Knit Plus Limited (Extension)

Plot-2036, Mouchak, Kaliakair, Gazipur

6 October 2024

2. Observation & CAP

Observation-4: Unrestraint brick wall (Extension Building-Production).

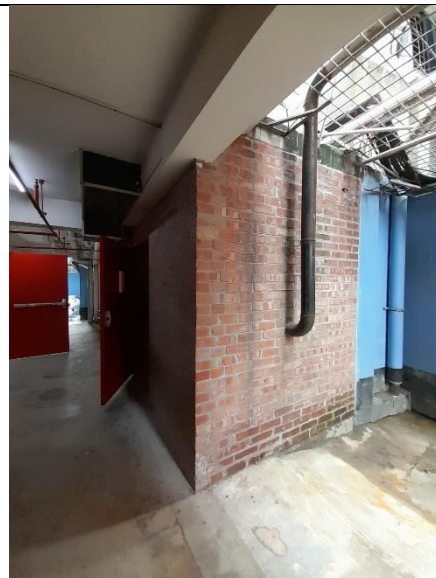
Description: Unrestrained brick wall of 3.5 m in height was observed on the 7th floor. Building engineer is required to check the stability and provide a head restraint on the top of the brick wall.

7.	Unrestraint brick wall (Extension Building-Production).	Building engineer is required to check the stability and provide a head restraint on the top of the brick wall.	within 6 weeks
